TMI-1

Three Mile Island Nuclear Station  
Procedure Change Request

PCR No. 1-MD-93-0075

1. Procedure EP1004.7 REG OFFSITE/ONSITE DOSE PROJECTIONS  
No Present Revision No Title

# AIRBORNE IODINE SAMPLE NOMOGRAPH

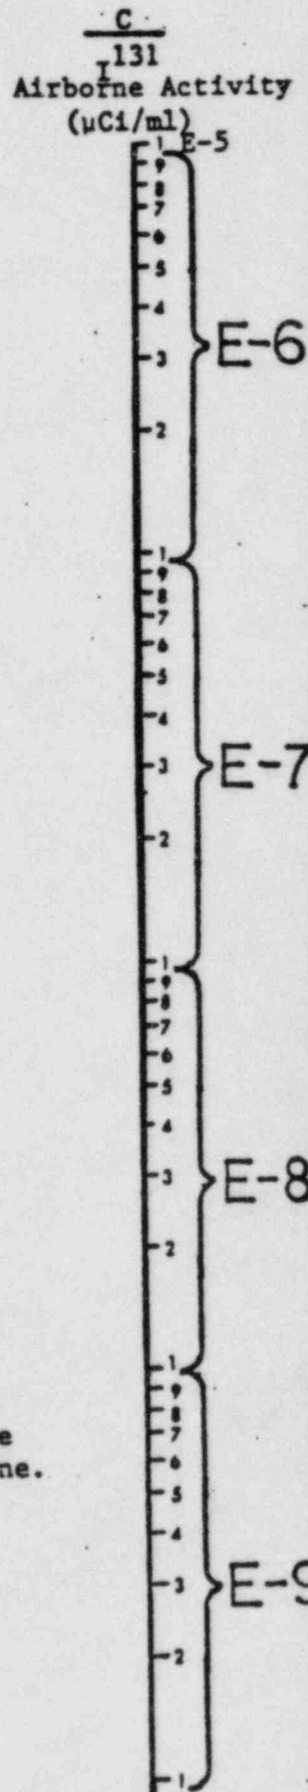
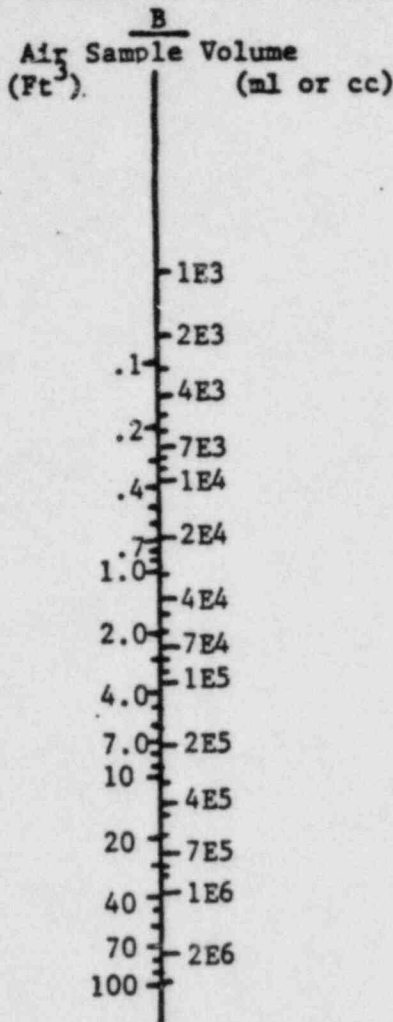
ATTACHMENT VII - AIRBORNE IODINE SAMPLE  
NOMOGRAPH

## ATTACHMENT VI

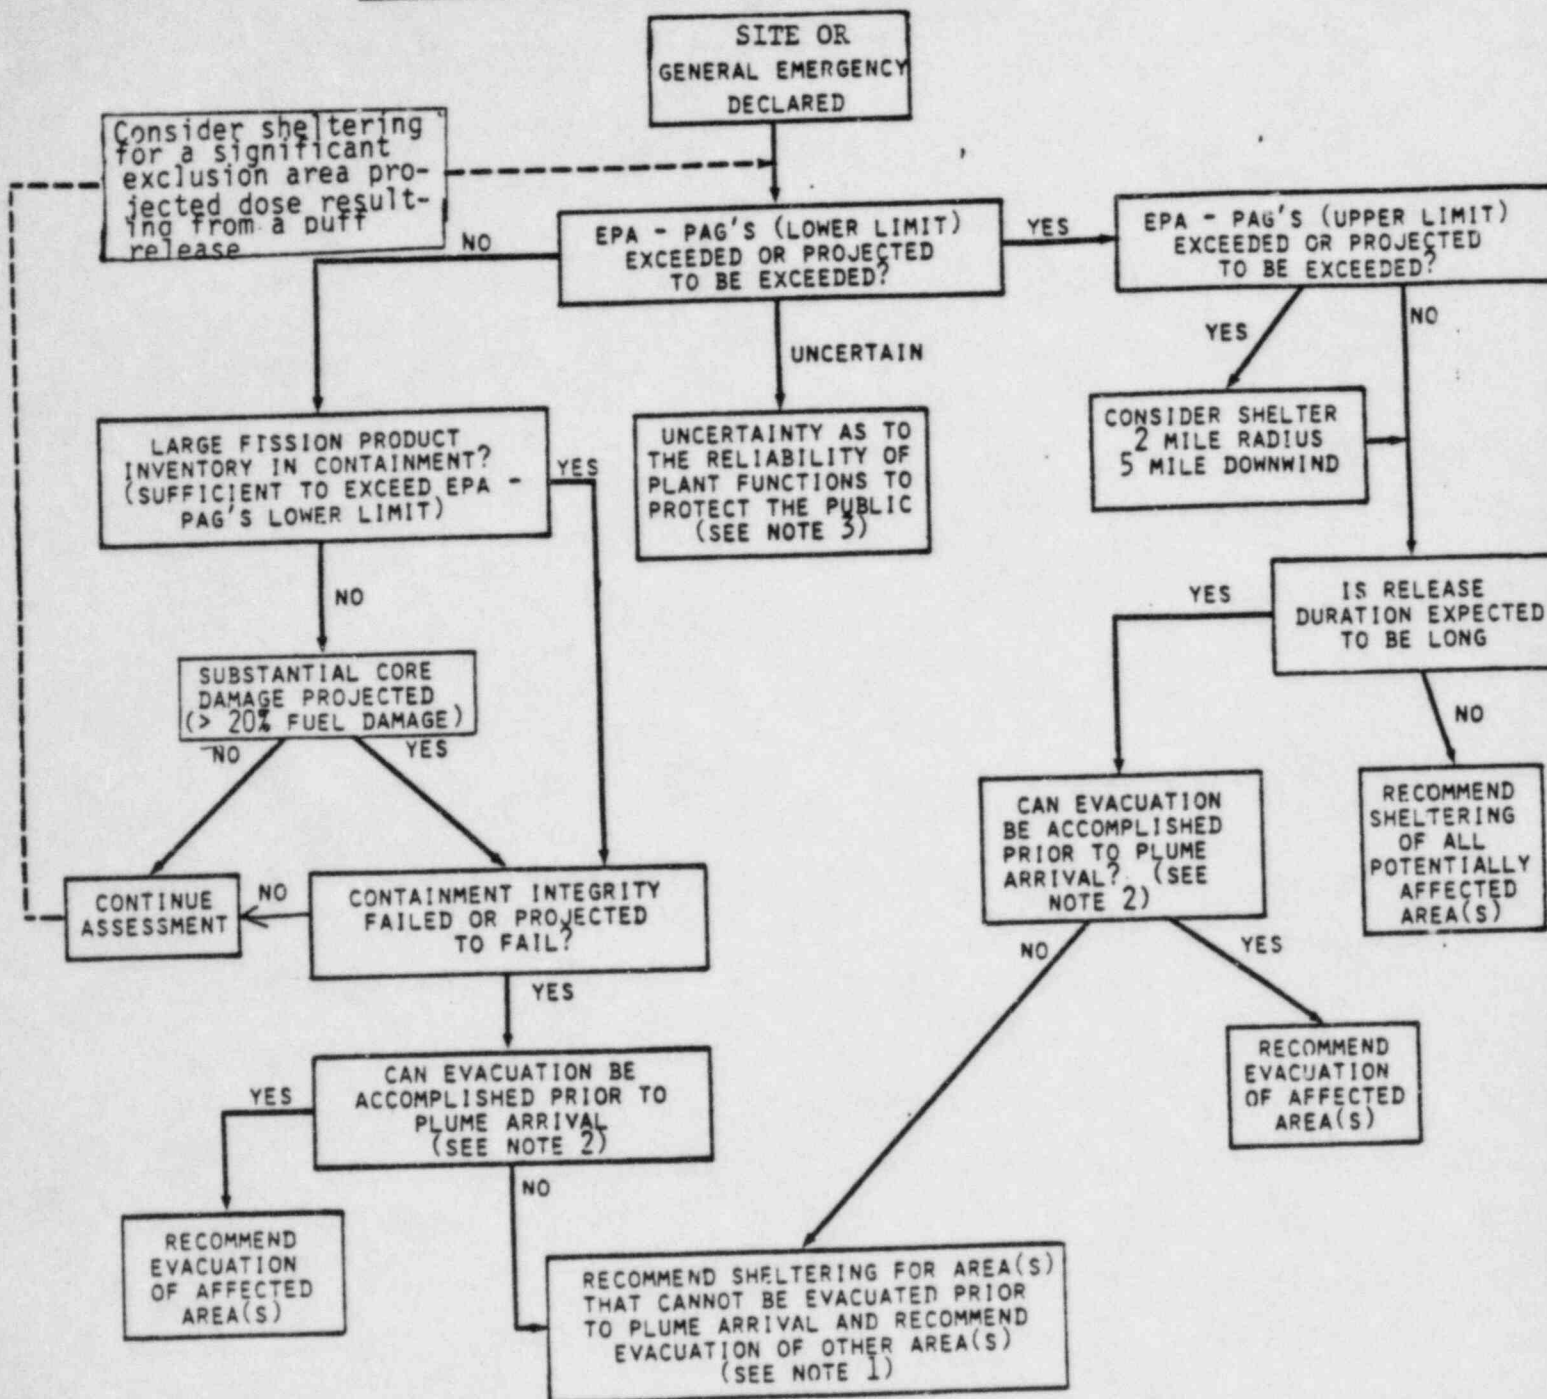
ATTACHMENT VI - PROTECTIVE ACTION GUIDES

B. DTSG Tube Rupture Leakrate

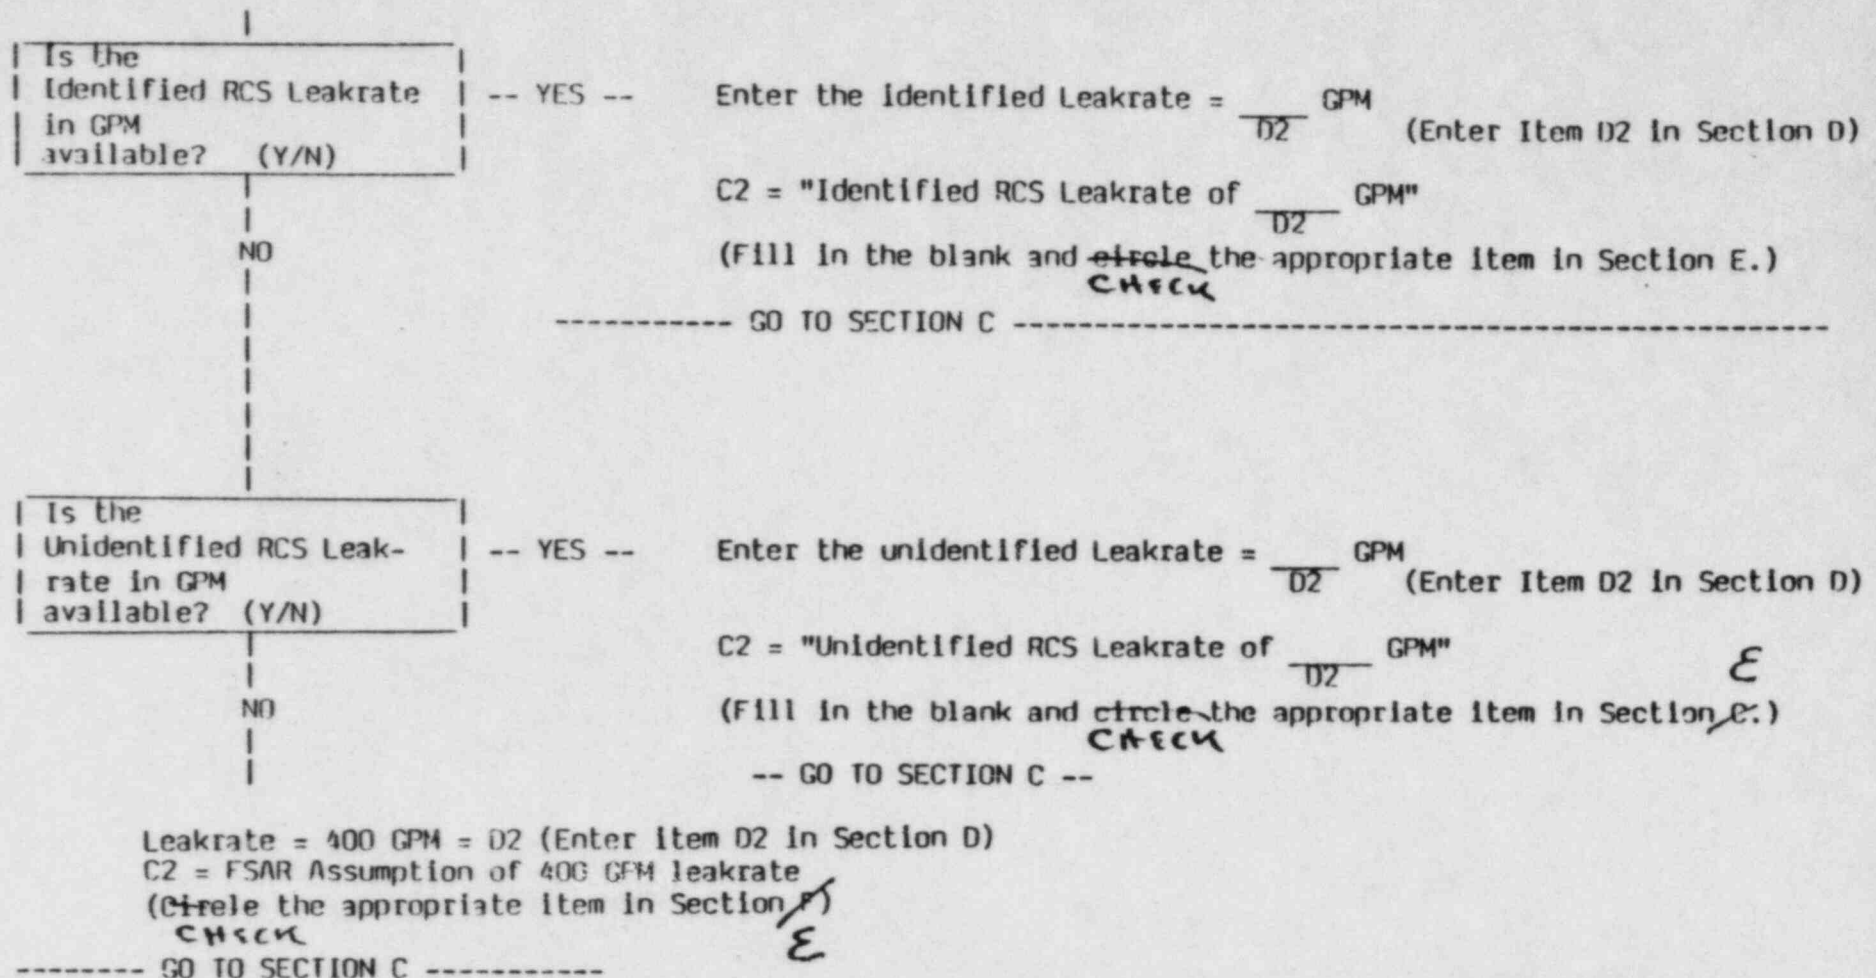
CASE 1: SECONDARY SIDE RELEASE
